SALISBURY PARK NORTH PHASE 1

TOWN OF PARKER

SITE PLAN

SITE PLAN SUBMITTAL
Page 1 of 311

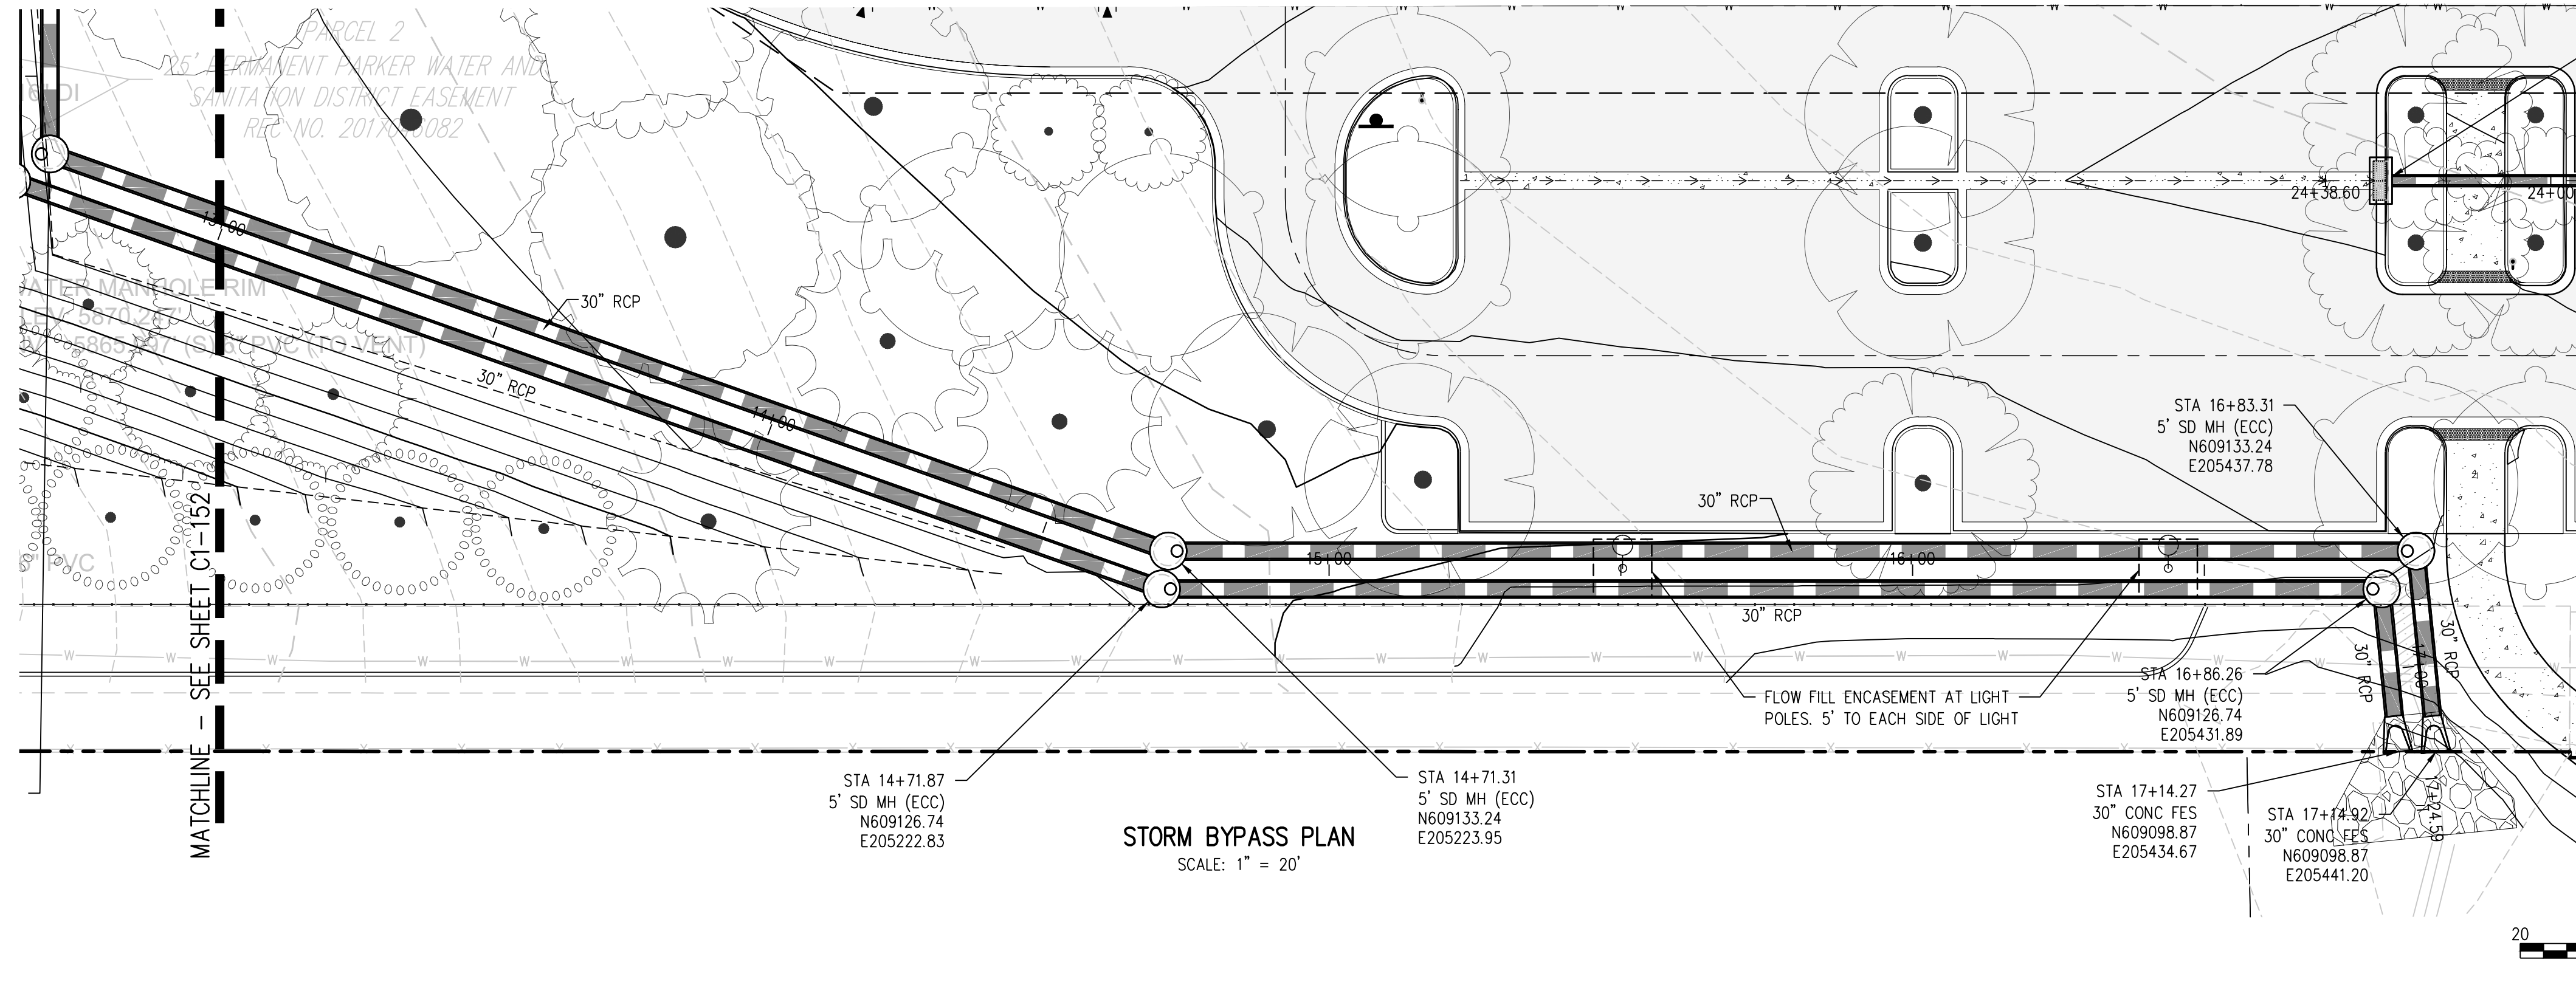
Please include flow direction arrows and a legend in the drainage plans.

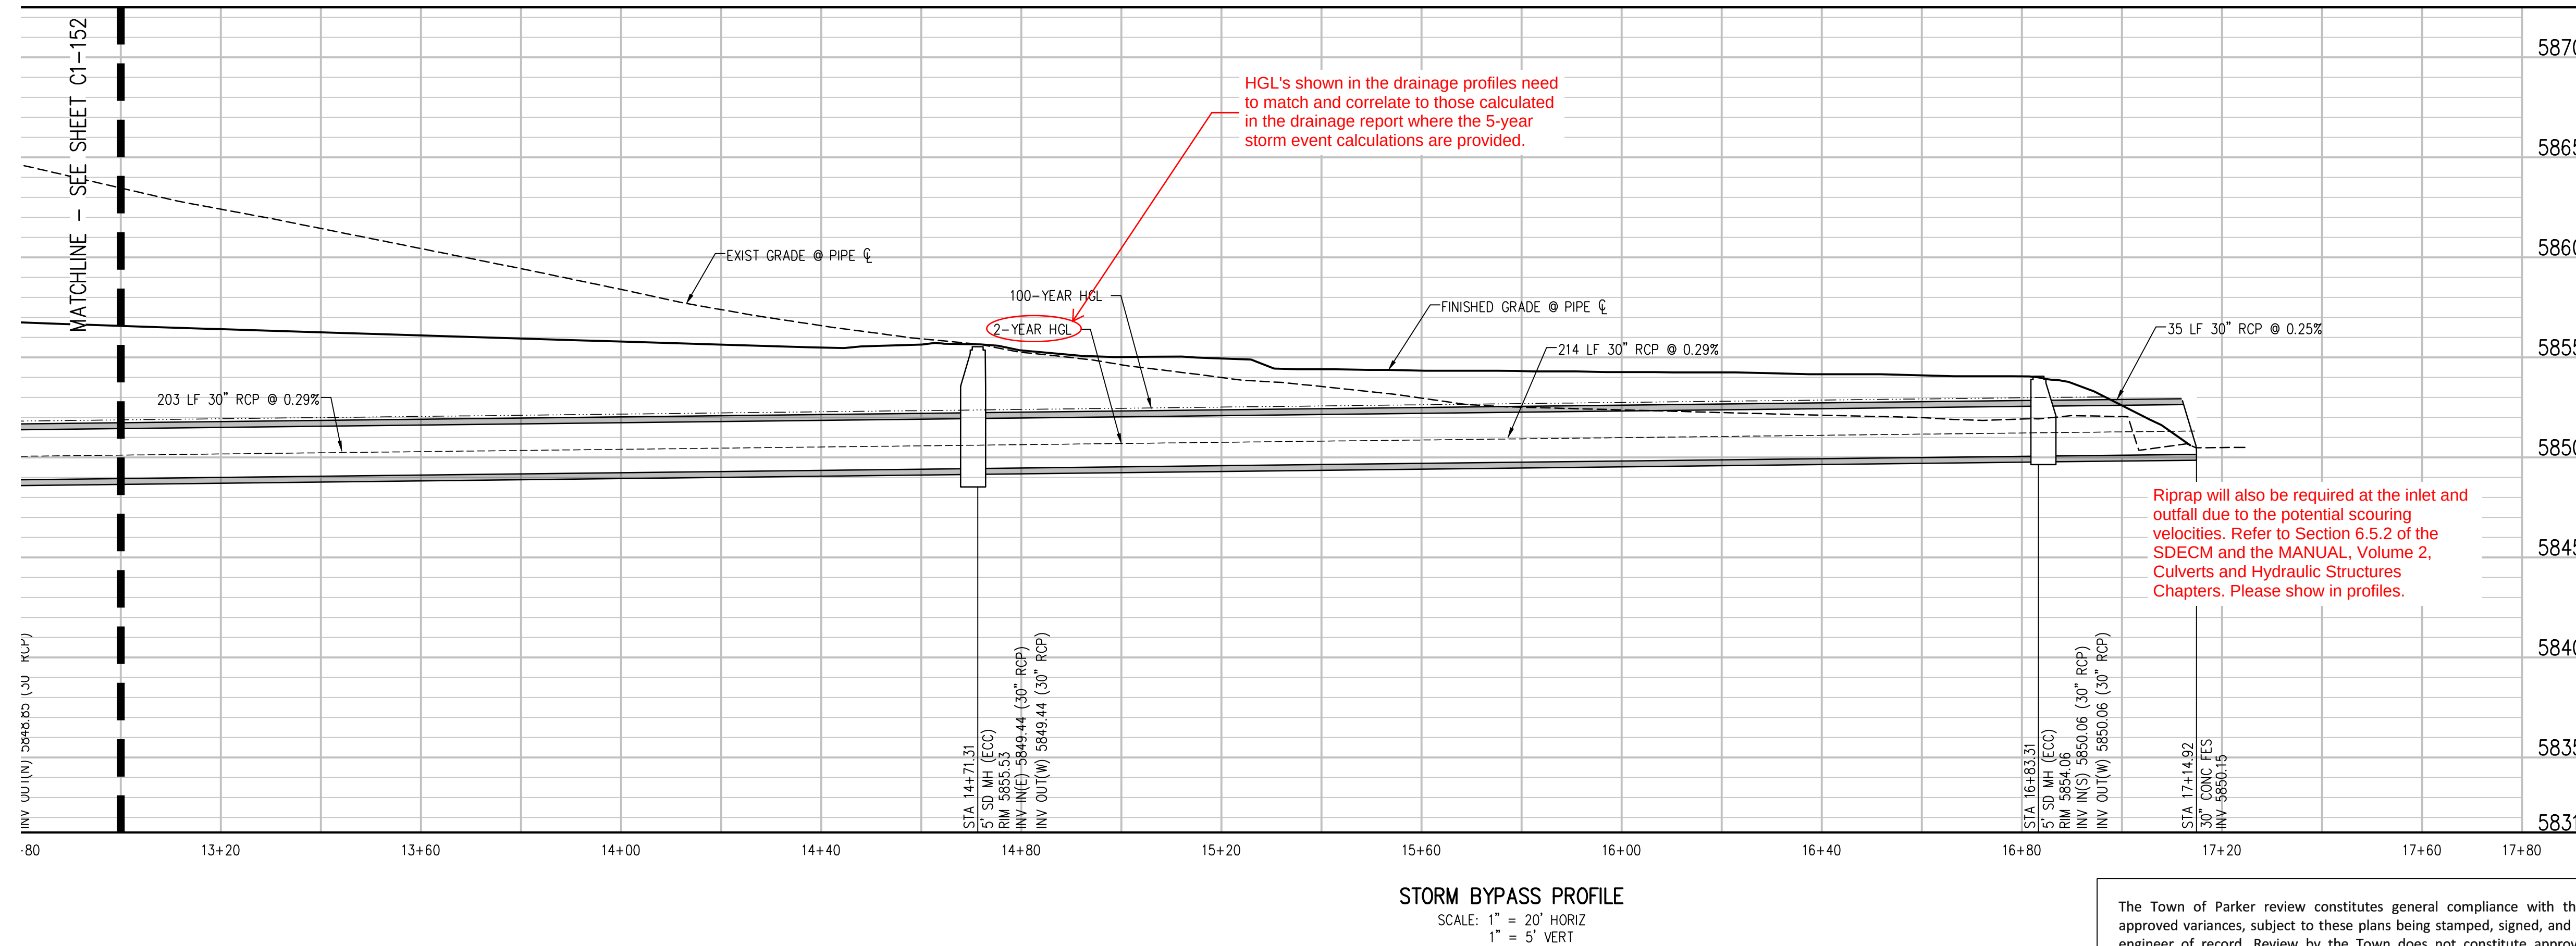
Please include existing and proposed grade contour labels and slopes. (TYP)

HGL's shown in the drainage profiles need to match and correlate to those calculated in the drainage report where the 5-year storm event calculations are provided.
